SUBJECT: BRAIDWOOD STATION, UNITS 1 AND 2 - STAFF ASSESSMENT OF INFORMATION PROVIDED PURSUANT TO TITLE 10 OF THE *CODE OF FEDERAL REGULATIONS* PART 50, SECTION 50.54(f), SEISMIC HAZARD REEVALUATIONS FOR RECOMMENDATION 2.1 OF THE NEAR-TERM TASK FORCE REVIEW OF INSIGHTS FROM THE FUKUSHIMA DAI-ICHI ACCIDENT (CAC NOS. MF3886 AND MF3887)

STAFF ASSESSMENT BY THE OFFICE OF NUCLEAR REACTOR REGULATION

RELATED TO SEISMIC HAZARD AND SCREENING REPORT

BRAIDWOOD STATION, UNITS 1 AND 2

Figure 3.3-1 Plot of Staff's and Licensee's Base Case Shear-Wave Velocity Profiles for the Braidwood site

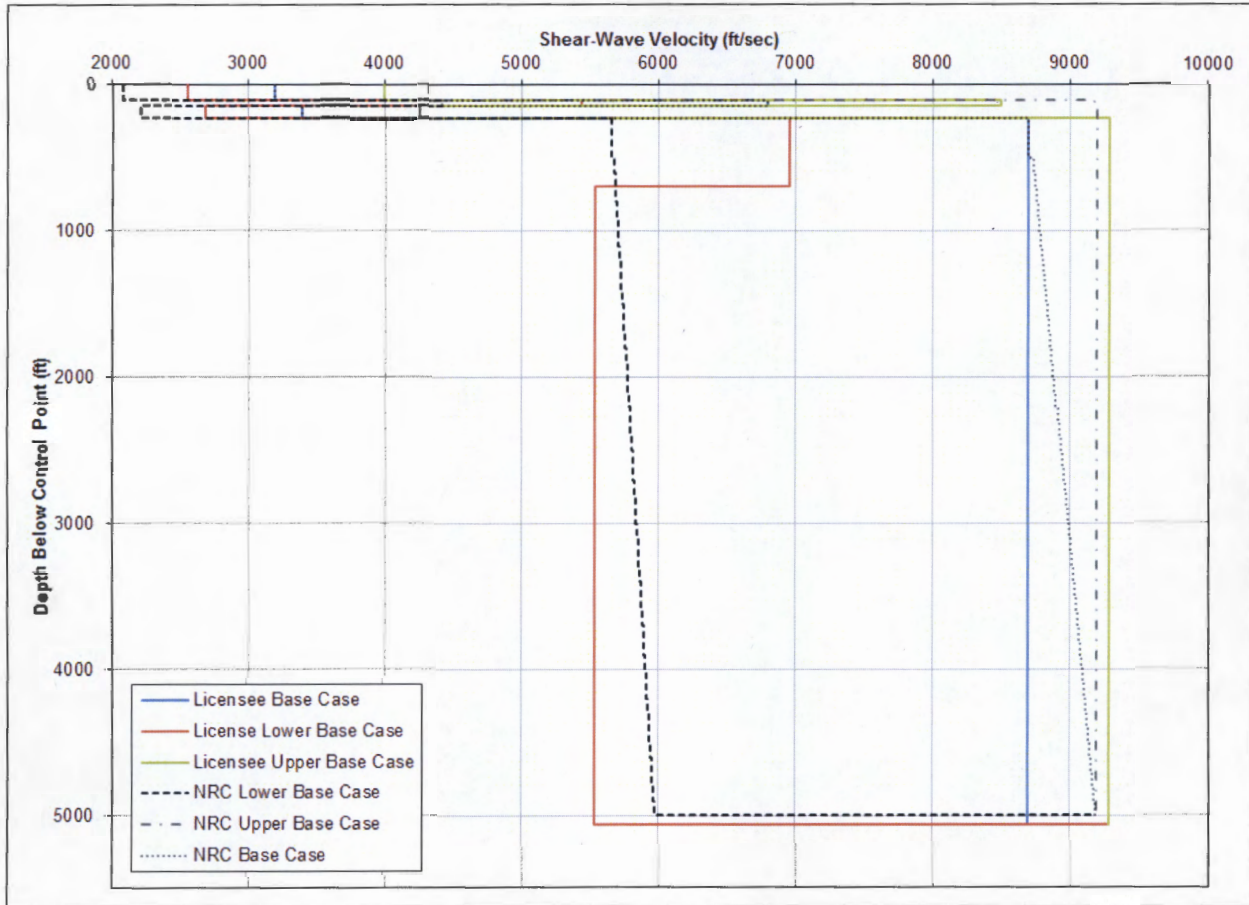
To capture the uncertainty in the subsurface geology, the licensee developed three site base case profiles for its site response analysis. The licensee developed the middle, or best estimate, profile using the measured shear-wave velocities from nearby downhole geophysical investigations to a depth of 224 ft. (68 m). Below a depth of 224 ft. (68 m), the licensee's extrapolated the shear wave velocities based on measurements made in the sound rock and assumed that base reference rock conditions are reached at an assumed depth of 5,062 ft. (1,543 m). To develop the lower and upper base case profiles, the licensee used a natural log standard deviation of 0.2 and 0.35 respectively. Table 2.3.2-1 and Figure 2.3.2-1 of the SHSR provide the licensee's shear-wave velocity profile for each of the three base cases. Figure 3.3-1 of this assessment shows the licensee's three shear-wave velocity base case profiles.

Due to the abundant amount of subsurface data for the Braidwood site, which the licensee incorporated into its best-estimate base case velocity profile, the NRC staff used the same profile with only minor modifications for its best-estimate profile. To capture the uncertainty in the depth to base rock, the NRC staff used a value of ± 500 ft. (± 152 m), which is less than the $\pm 1,519$ ft. (± 463 m), depth to base rock randomization used by the licensee. Similar to the licensee's approach, the NRC staff also developed lower and upper profiles to capture the uncertainty in the subsurface shear wave velocities across the site. Figure 3.3-1 of this assessment illustrates the licensee's and staff's base case shear wave velocity profiles.

Figure 3.3-3 Plot Comparing the Staff's and the Licensee's Mean Control Point Hazard Curves at a Variety of Frequencies for the Braidwood site

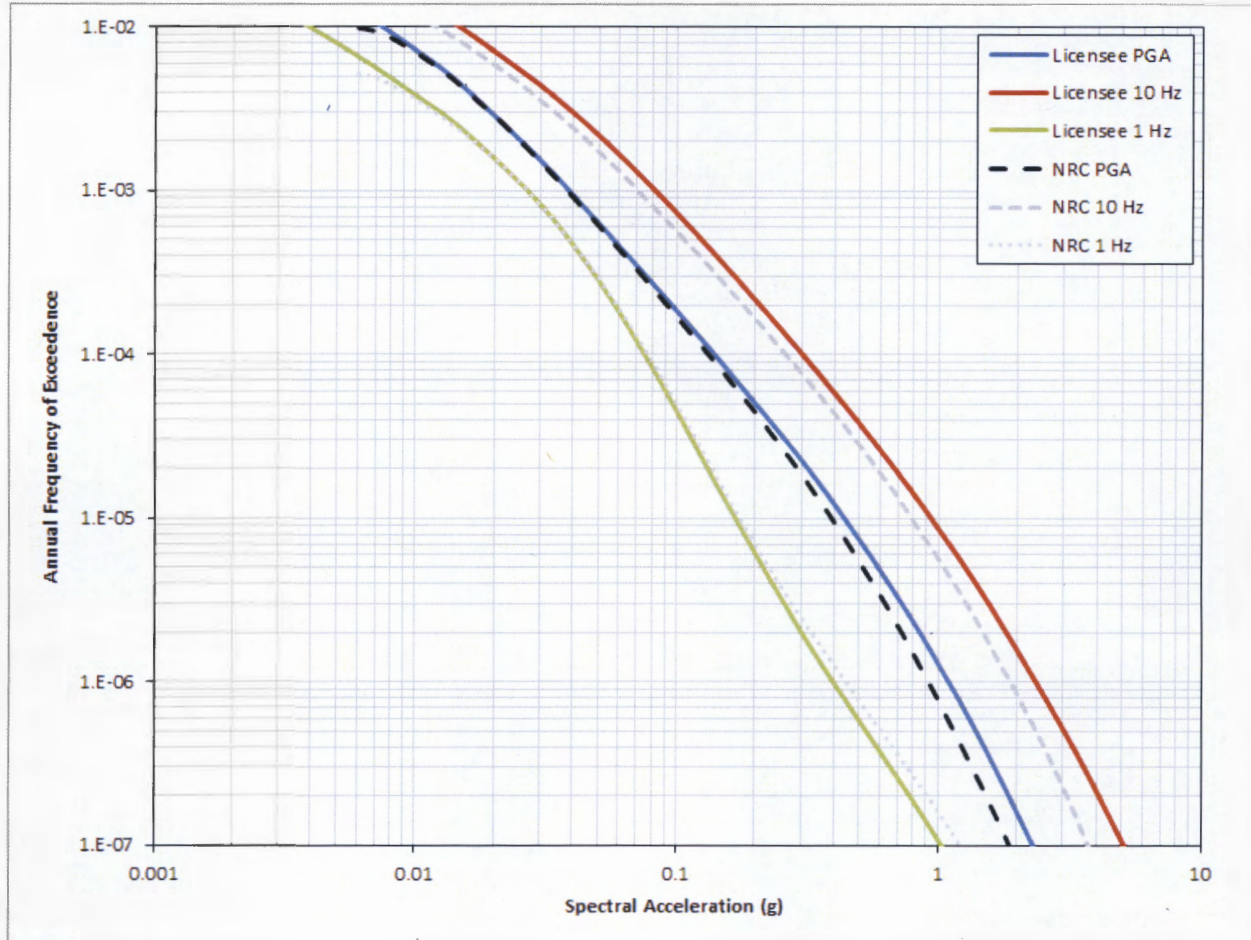
In summary, the NRC staff concludes that the licensee's site response was conducted using present-day guidance and methodology, including the NRC-endorsed SPID. The NRC staff performed independent calculations which confirmed that the licensee's amplification factors and control point hazard curves adequately characterize the site response, including the uncertainty associated with the subsurface material properties, for the Braidwood site.

Figure 3.4-1 Comparison of the Staff's GMRS with Licensee's GMRS and the SSE for the Braidwood site

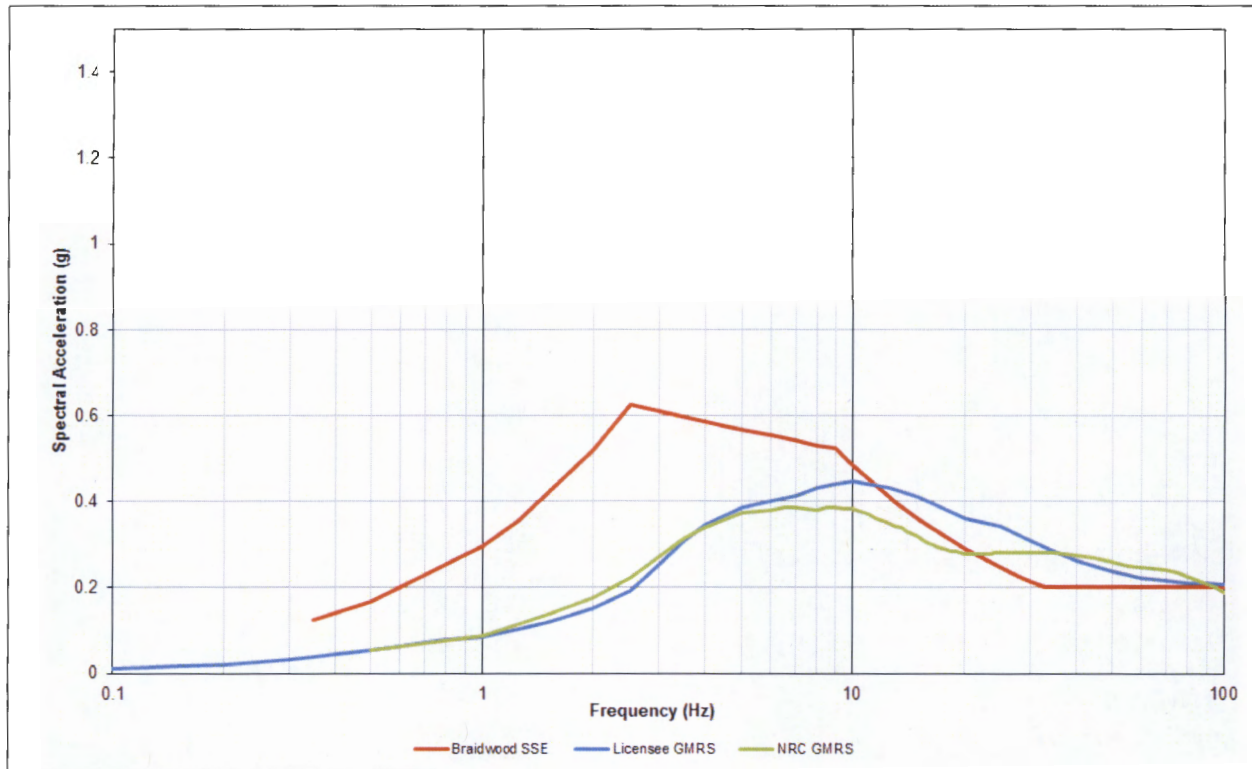
The NRC staff independently calculated the 10^{-4} and 10^{-5} UHRS using the results of its confirmatory PSHA and site response analyses, as described in Sections 3.2 and 3.3 of this staff assessment, respectively. As shown in Figure 3.4-1 of this assessment, the licensee's GMRS shape is generally similar to that calculated by the NRC staff. However, the licensee's GMRS is higher than the staff's in the range of approximately 5 to 30 Hz. As described above in Section 3.3, the NRC staff concludes that these differences are primarily due to the differences in the site response analyses performed by the licensee and NRC staff.
